IN THE DRAWINGS:

REMARKS

FIG. 1

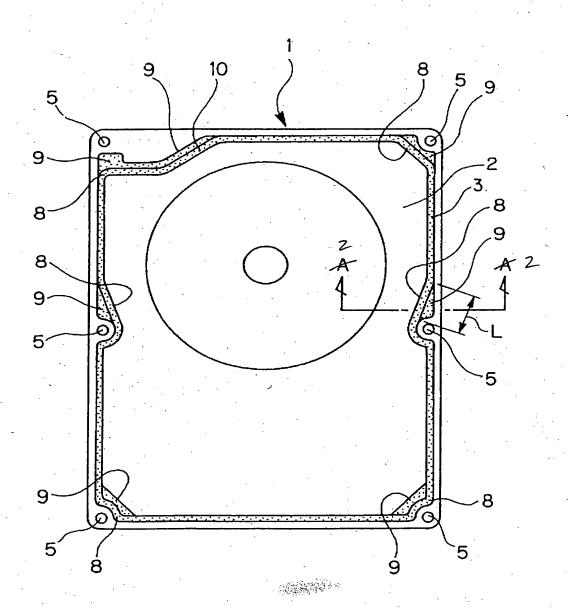
In the Office Action, the Examiner objected to the Figures 1 and 5-7 under 37 CFR 1.83(a). The specification was objected to under 35 U.S.C. 112, first paragraph, because of informalities. Claims 1-5 were rejected under 35 U.S.C. 112, second paragraph, as being indefinite. Claims 1-3 and 5 were rejected under 35 U.S.C. 103(a) as being unpatentable over Miyake et al. in Japanese Patent Application Publication No. JP 2003-049949 in view of any one of Shikano in U.S. Patent No. 5,568,341, Ishii et al. in Japanese Patent Application Publication No. JP 09-282860, or Nakada in Japanese Patent Application No. JP 05-326731. Claim 4 was rejected under 35 U.S.C. 103(a) as being unpatentable over Miyake et al. in Japanese Patent Application Publication No. JP 2003-049949 in view of any one of Shikano in U.S. Patent No. 5,568,341, Ishii et al. in Japanese Patent Application Publication No. JP 09-282860, or Nakada in Japanese Patent Application No. JP 05-326731 and further in view of Satoh et al. in U.S. Patent No. 6,623,684.

A Letter to the Official Draftsman is attached with proposed drawing corrections to Figures 1 and 5-7.

The attached sheets of drawings include changes to Figs. 1 and 5-7. These sheets, which include Figs. 1 and 5-7, replace the original sheets of Figs. 1 and 5-7.

In response to the informalities noted by the Examiner, claims 1-5 have been amended and claim 6 has been added. The informalities noted by the Examiner in the §112, second paragraph rejection have been corrected. The "inflection portion" noted by the Examiner are described and illustrated in the drawings as "inflection

portion 10", following the contour of the packing 3 with a curving or a bending as "inflection" is normally defined.

FIG. 6

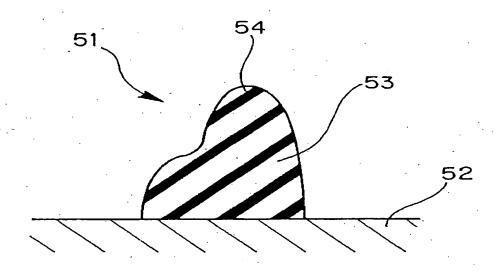
The shape of JP 2003-049949 is the same as the shape illustrated in Fig. 6, which is referred to as prior art in the present application. In JP 2003-049949, there is a packing overhang portion at the side opposite to a lip (right side on drawing) but no packing overhang portion at the side of the lip (left side on drawing).
